**Planning and Environment Committee Meeting No. 12/14**

<b>Item</b>		<b>Page</b>
1	CONFIRMATION OF MINUTES - Meeting held on 4 November 2014.....	1
2	21 GORDON STREET, EASTWOOD - LOT 10 SECTION 4 IN DP 7076. DA for a multi dwelling housing development with 4 units - 1 x 2- storey 5 bedroom dwelling at the front and 3 x single storey 3 bedroom dwellings at the rear. LDA2014/0089. <i>INTERVIEW 5.00PM</i> .....	5
3	7-9 RUTLEDGE STREET, EASTWOOD, LOT 1 DP1111051 and LOT 24 DP 653568. Staged Development: mixed use development comprising 613m2 of retail space and 100 residential apartments upon completion of both stages & strata subdivision. LDA 2011/0612.....	80

**Figure 3: Site Plan extract of the proposed development with each of the four (4) dwellings proposed highlighted in blue and labelled in red. The red perimeter represents the boundary of the subject site at 21 Gordon Street, Eastwood.**

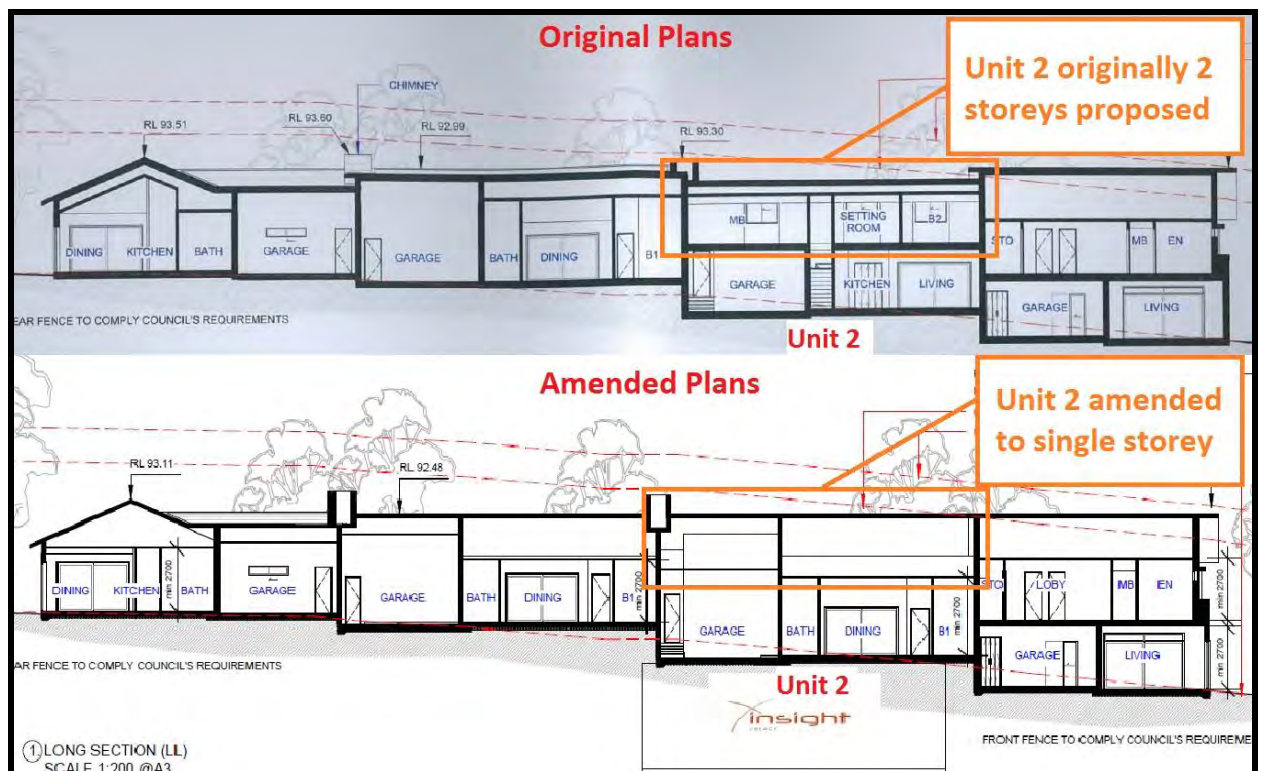
Concern was originally raised that the proposal did not comply with the Number of Storeys control contained in Ryde DCP 2014 – in particular because Unit 2 was proposed to be a two-storey development (in the original DA plans) whereas the DCP control states that dwellings that do not front the street are to be single-storey only.

This has been rectified by the amended plans submitted on 11 July 2014 (in response to Council’s letter dated 21 May 2014), and the development now complies with the height/number of storeys provisions of Ryde DCP 2014. See **Figure 5** below.

**Figure 6. Extract of the revised ground floor plan demonstrating the significant separation distances between sensitive areas of the proposed development and the neighbouring dwellings.**

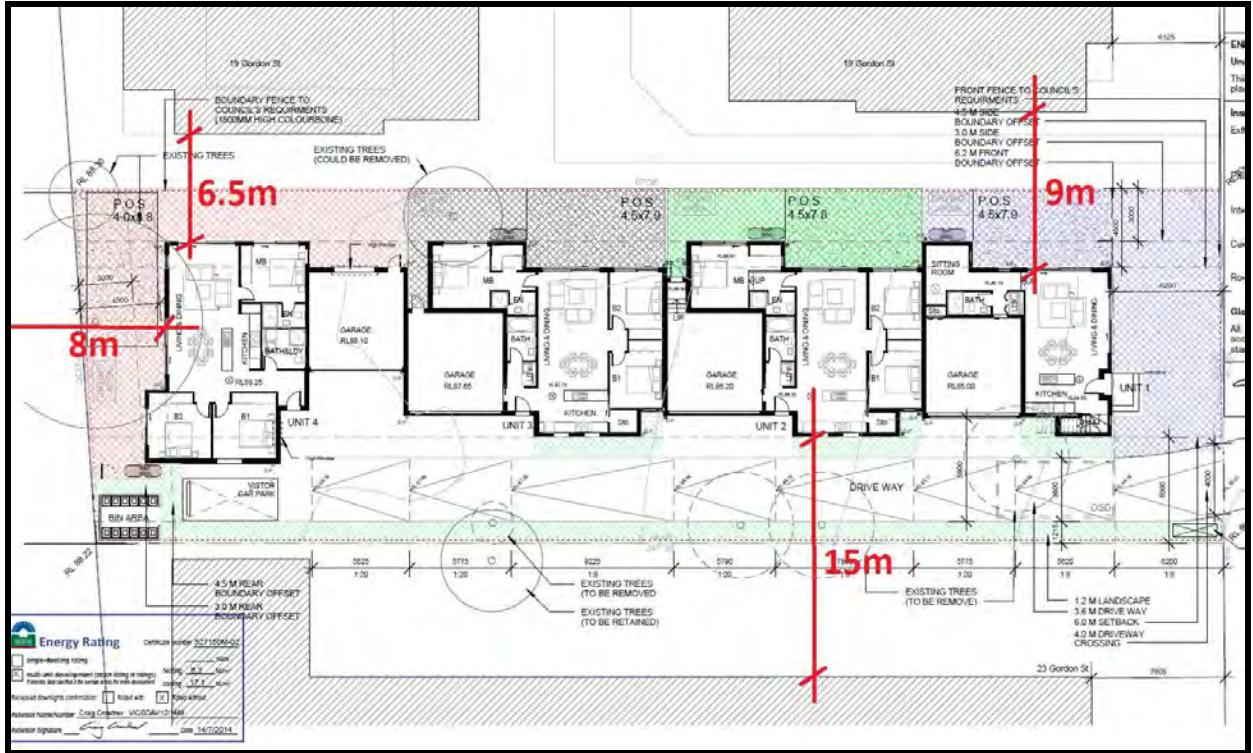
The proposed development incorporates a range of privacy measures. As demonstrated in **Figure 6**, the siting of the proposal is such that the separation with neighbouring dwellings is significant at up to 15m on the southern side. **Figure 7, 8 & 9** demonstrate that in addition to the significant separation, privacy is achieved due to the fact that the rear units are only single storey which means that the proposed 1.8m high boundary fencing almost completely prevents any overlooking. It is acknowledged that there are some windows that may afford overlooking due to their height slightly above the fence line, however these windows are not to living spaces and as such are not considered to present a significant privacy concern.

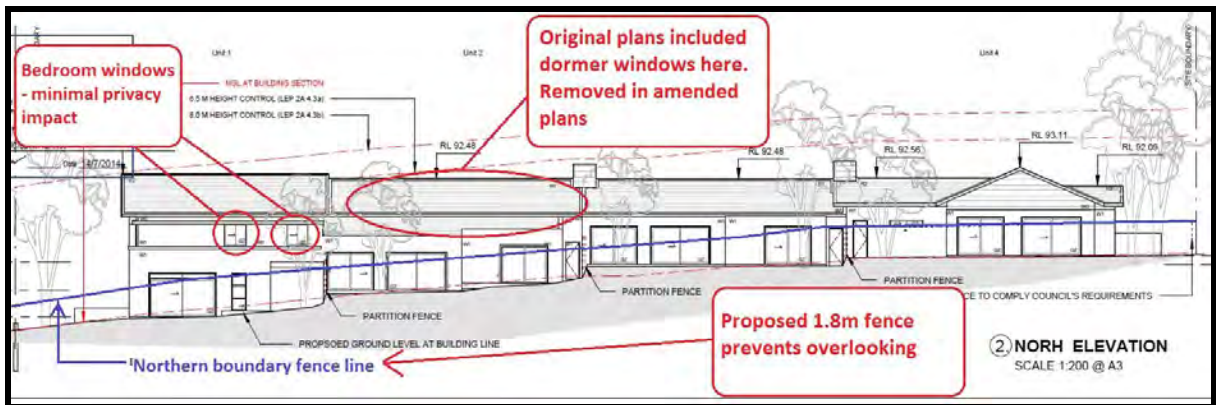
It is noted that privacy concerns raised by the objectors were primarily concerned with the originally proposed north side facing dormer windows of the originally proposed two- storey 'Unit 2'. As discussed above, the amended plans have removed the second storey of 'Unit 2' making this unit now single storey.

**Figure 10. Diagram illustrating the proposed trees to be retained and those trees to be removal on the subject site (from Landscape Assessment).**

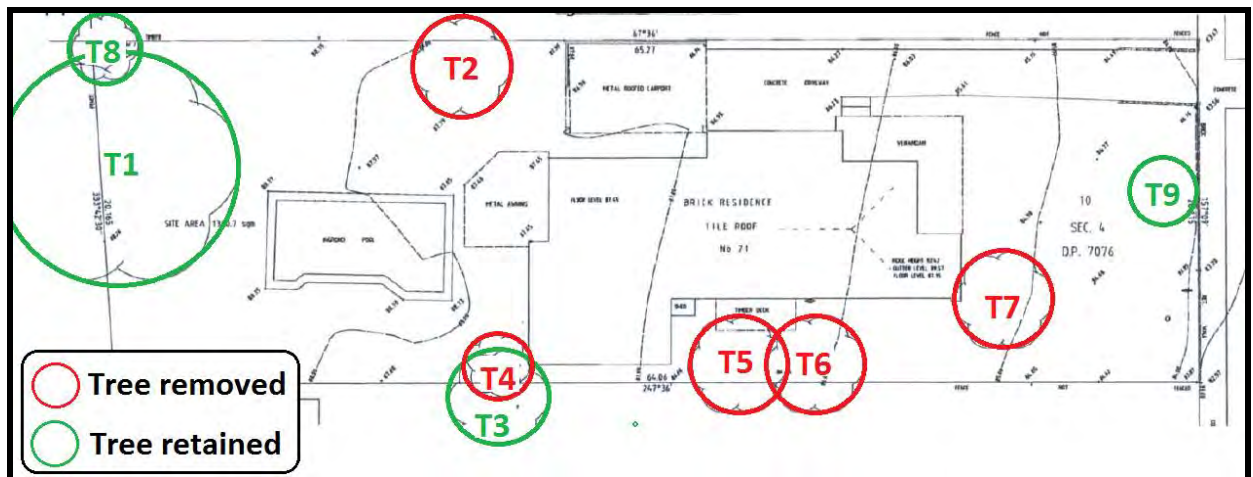
The submissions raised concerns that the proposed development could possibly damage plantings on the adjoining property to the south, No. 23 Gordon Street. In addition, concerns were raised about the proposed removal of two (2) Jacaranda trees located along the southern boundary of the site.

In regards to the possible damage to plantings on the adjoining properties the Landscape referral has considered the *Callistemon viminalis* (Tree 3) located within No. 23 Gordon Street, adjacent to the southern boundary of the subject site, and has imposed a condition of consent to ensure appropriate protection of this tree. The condition is as follows:

**Project Arborist** - A Project Arborist with minimum AQF level 5 qualifications is to be engaged to ensure adequate tree protection measures are put in place for all trees to be retained on the subject site and neighbouring allotments and that recommendations contained within Arboricultural Impact Assessment dated 6 March 2014 prepared by Redgum Horticulture are carried out. All trees are to be monitored to ensure adequate health throughout the construction period is maintained. Additionally, all work within the Tree Protection Zones is to be supervised throughout construction. Details of the Project Arborist are to be submitted to Council prior to the commencement of construction.

**Figure 11. Site plan extract showing that the proposed driveway width is 3.6m which does not include the width of the adjacent landscaping strips.**

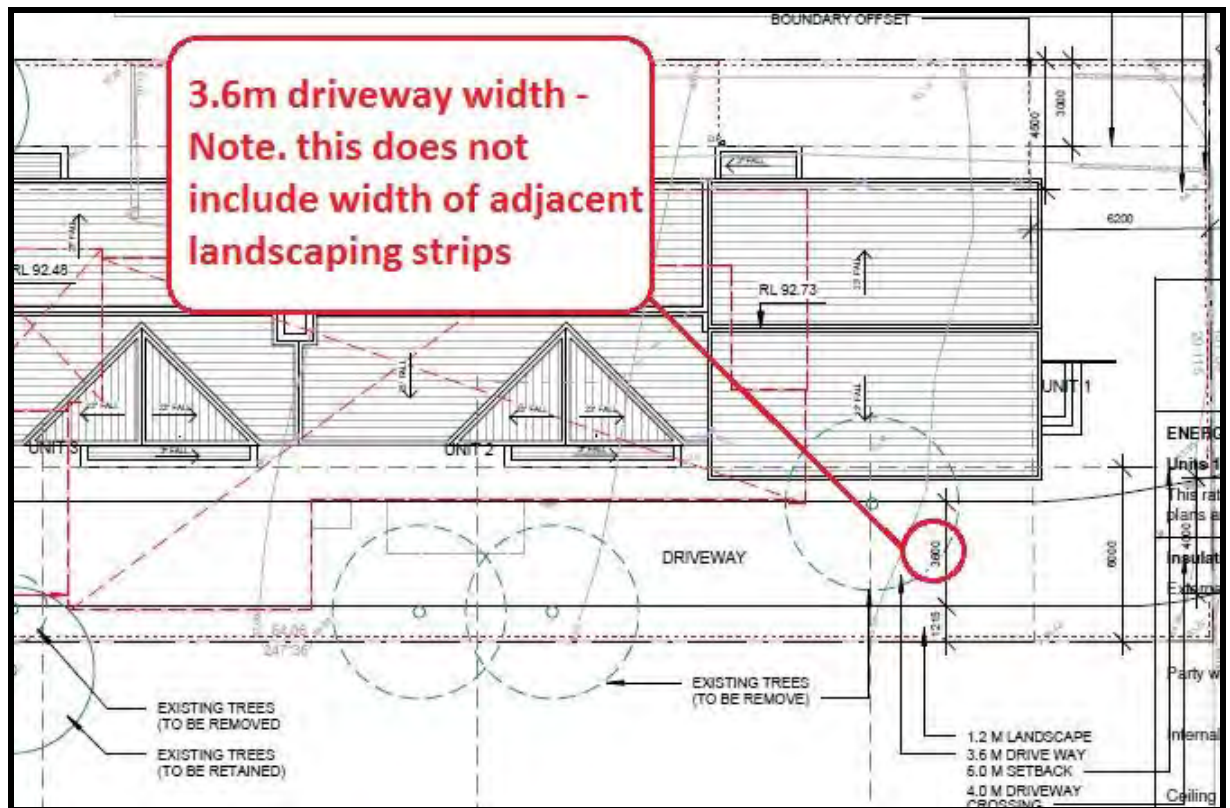
An assessment of the proposed development has determined that the proposed driveway width is to be 4m at the front boundary and then narrowing to 3.6m adjacent to the proposed dwellings (see **Figure 11**). The application has been referred to Council's Senior Development Engineer who has raised no objection to the proposed width of the driveway. It appears that the objectors have misread the plans believing the landscaping strip adjacent to the driveway are included in the driveway width.

Figure 12. Diagram indicating the shadows cast by the proposed development and the portion of that shadow that will affect the neighbouring property to the south of the subject site at No 23 Gordon Street.

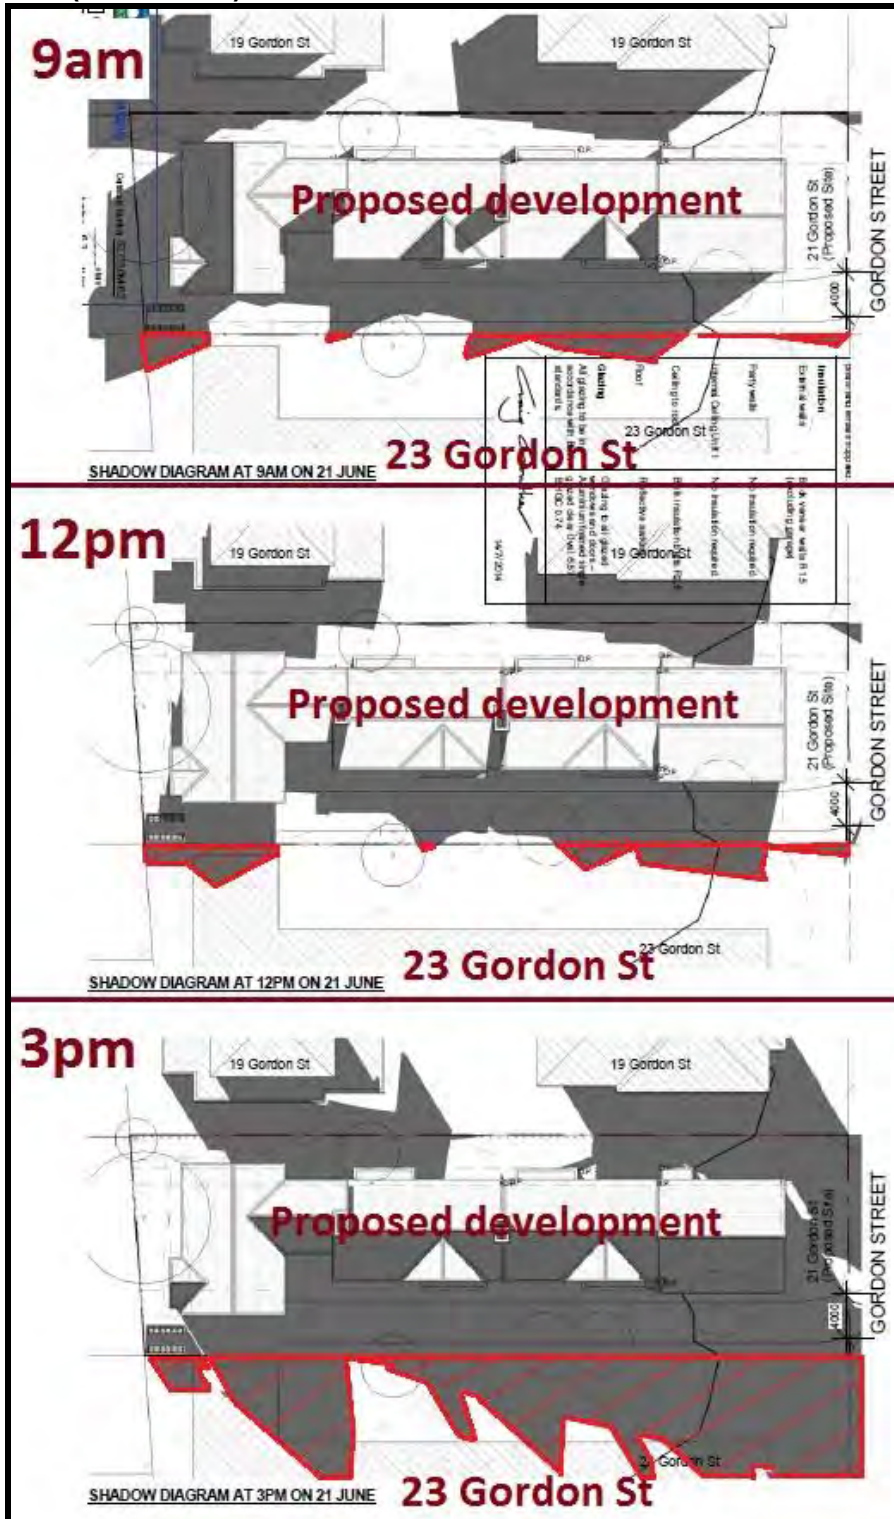
As demonstrated in **Figure 12 and 13**, the shadow diagrams indicate that the shadows of the proposed development will not have a significant impact on the neighbouring properties.

Due to the east-west orientation of the site, the shadows will only impact on the neighbouring property to the south at No. 23 Gordon Street. In regards to this property, it is apparent from the shadow diagrams that it will only be affected between 12pm and 3pm on June 21. **Figure 13** demonstrates that at the worst time at 3pm, the shadows will only have a very minor impact on the actual dwellings at No. 23 Gordon Street. The majority of the shadows will fall on the driveway of No. 23 Gordon Street which runs along the adjoining boundary with the subject site.

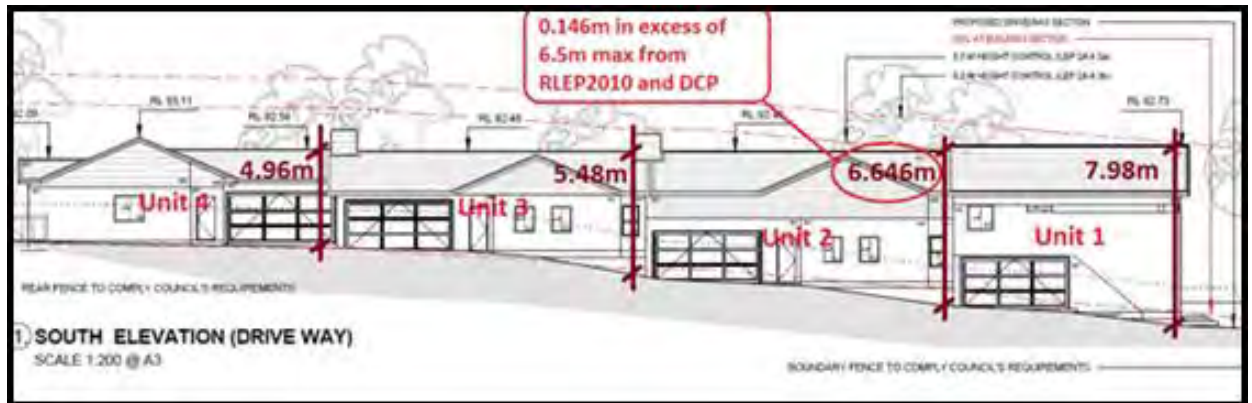
Proposed 'Dwelling 2' does not have a street frontage so the relevant maximum building height is 6.5m. Accordingly, at 6.646m, the height of this dwelling fails to comply with the aforementioned development standard contained within the Ryde LEP 2010 (see **Figure 17-18** below).

- No formal Clause 4.6 Variation has been submitted with the subject DA from the applicant demonstrating that strict compliance with the standard, in this particular case, would be unreasonable or unnecessary. Furthermore there has been no demonstration that there are sufficient environmental planning grounds to justify contravening the Ryde LEP 2010 development standard.

- It is considered that a reduction in height of this ridge level could be undertaken without impacting on the floor plan or layout of the development. Additionally, the slight reduction in height of this ridge level which is needed for the dwelling to comply with the development standard is not considered to be to the detriment of the architectural aesthetic of the building.
- The proposed building height is not considered to achieve the key objectives of the standard. Provided below is a list of each of the objectives of the 'height of buildings' development standard, along with a comment on how the proposed development performs against each of these objectives by the Assessing Officer.

The deferred commencement conditioning of this building height development standard is considered feasible as it could be undertaken without impacting on the floor plan of the dwelling beneath. See Deferred Commencement condition 1(a).

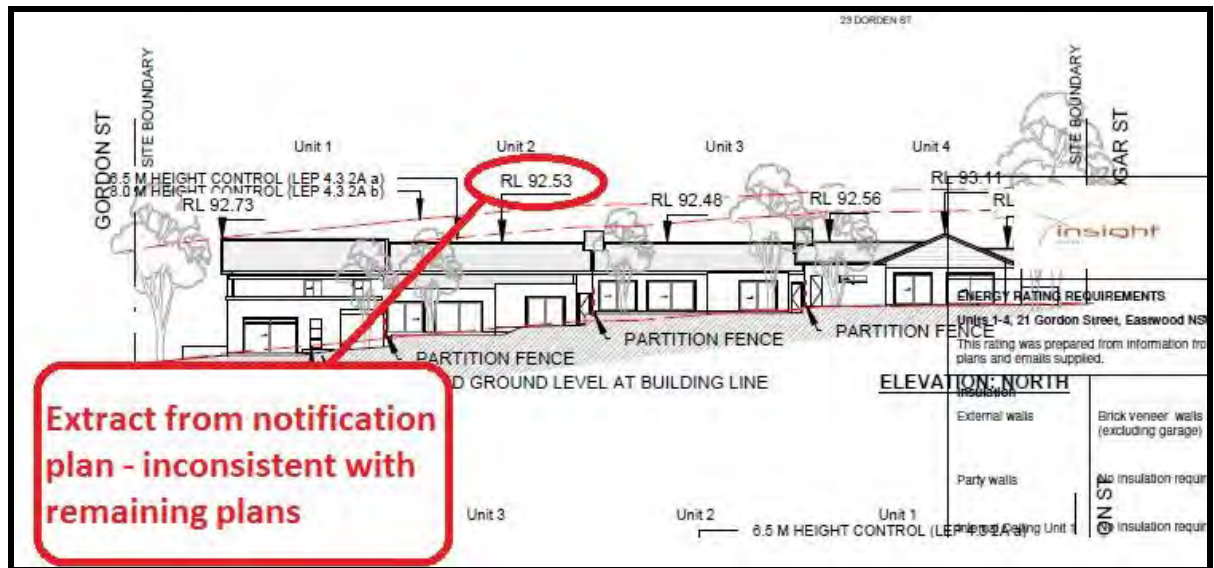
It is also noted that the amended plans are inconsistent as to the ridge level of 'Dwelling 2'. The 'northern elevation' as shown on the 'notification plans' shows the ridge level of 'Dwelling 2' at RL 92.53 (see **Figure 18**). The remaining plans including the separate 'northern elevation' shows the ridge level at RL 92.48. In either case, the height of 'Dwelling 2' exceeds the 6.5m maximum height as stipulated in the aforementioned controls.

**Figure 19. Northern elevation diagram demonstrating that the proposal includes a combination of cut and fill to minimise the level of land alteration.**

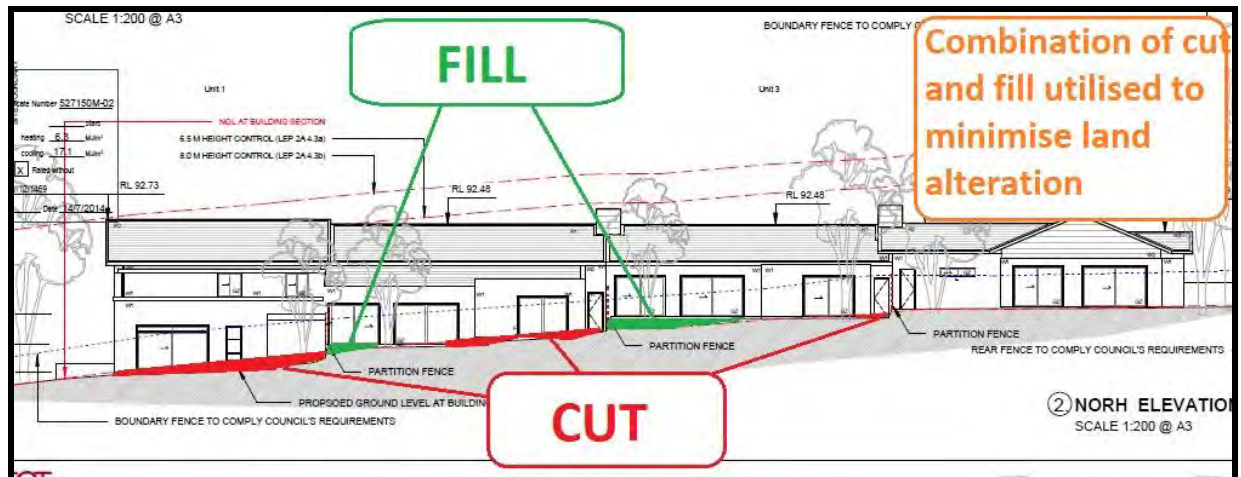
- Given the considerable slope of the site, the exceedance of a maximum of 300mm above the control is considered to be minimal.
- As demonstrated in **Figure 19**, a combination of cut and fill has been utilised to minimise the level of land alteration.
- The alteration of levels in the Dwelling 1, 2 and 3 courtyards along the northern boundary will make them flatter and hence more usable spaces. This will provide future residents with an enhanced level of amenity.
- The alteration of the levels along the driveway on the southern side is practical reasons to provide even access to the attached garages.
- The proposed levels of cut and fill will not result in any privacy impacts for the neighbouring properties. Refer to the 'submissions' section of this report for a full discussion of the privacy impacts of the proposed development.

Figure 20. Extract of Ground Floor Plan showing the location of the bin storage area located within a common area in the south-western corner of the site and adjacent to two (2) adjoining properties.

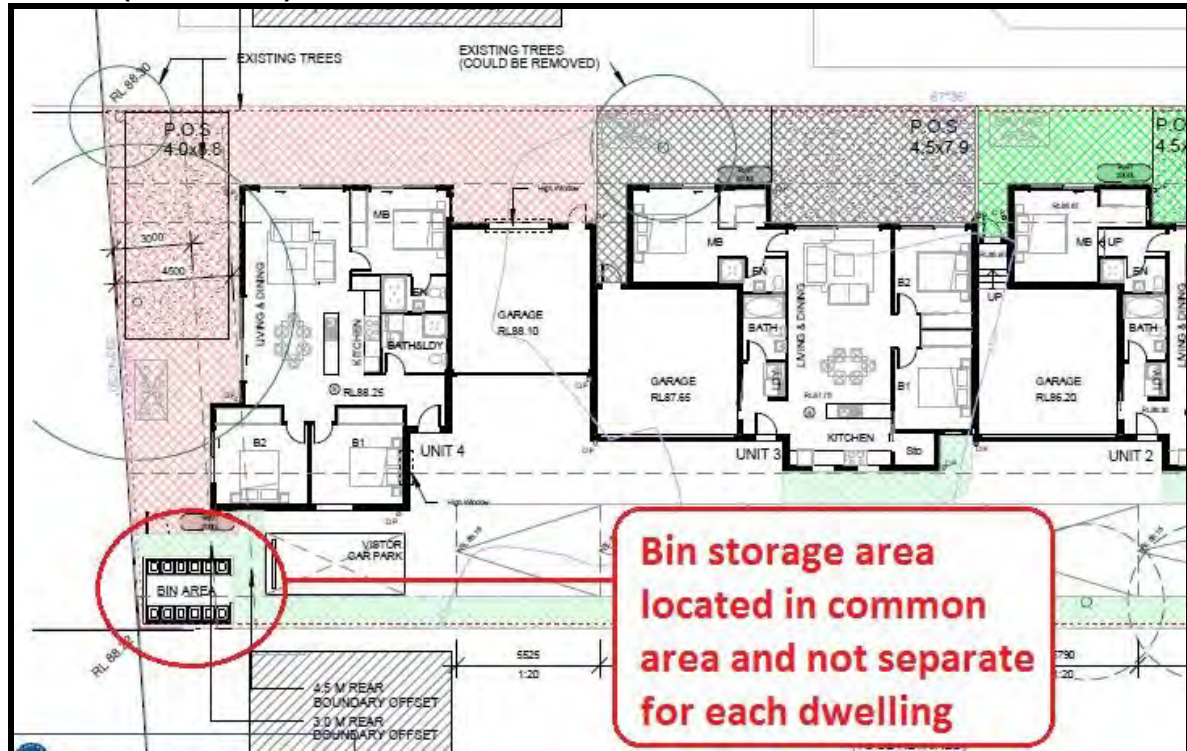
An assessment of the plans has revealed that the bins are proposed to be stored in a bin area located in a common area in the rear south-western corner of the site (demonstrated in **Figure 20**). Accordingly, each dwelling will not be provided with a bin storage area and the storage area will be located within a common area of the development. This arrangement is a non-compliance with the abovementioned control and as such is unacceptable as it will pose a visual impact and impose odours on adjoining property.

***Location of garbage bin enclosures.*** *The proposed bin storage area located in the south-western corner of the site be deleted and replaced with separate bin storage areas for each dwelling in accordance with Section 4.8 of Part 3.4 of the Ryde DCP 2014.*
